APPLICANT'S RESPONSE TO INTERESTED PARTIES' DEADLINE 1 SUBMISSIONS NUMBER: 9.12

Cory Decarbonisation Project

PINS Reference: EN010128

DECEMBER 2024

Figure 3: CCS facility footprint versus capacity

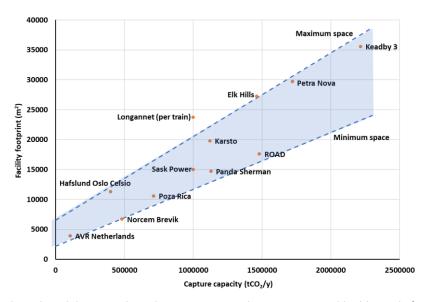
To address Figure 3 as referenced in Mr Hewitt's Written Representation first. Section 3.2 of Carbon Capture from EfW considers, briefly, *'on-site space availability for CCS'*. The paragraph preceding Figure 3 in the report states:

The paragraph following Figure 3 in Carbon Capture from EfW then sets out how the data is used in the report.

thus the facility was not considered further in the analysis. The spatial analysis was considered independently for each CO2 emission factor.'
			It is clear that Figure 3 is not presented as a guide of suitable site size for carbon capture projects. It is being used simply as a way of shortlisting projects to consider further in the study.
			Carbon Capture from EfW makes clear (not least in the Executive Summary) that:
			'In fact, the significance of EfW+CCS in meeting climate objectives cannot be overstated, as the practice can contribute at least three different climate benefits'
			This report clearly demonstrates that carbon capture at energy from waste facilities should be supported and will be an important and relevant contributor to meeting policy. The full report is provided at Appendix E to this response.
REP1-065	James Hewitt	Land Acquisition	Mr Hewitt raised this matter at CAH1, to which the Applicant's response is set
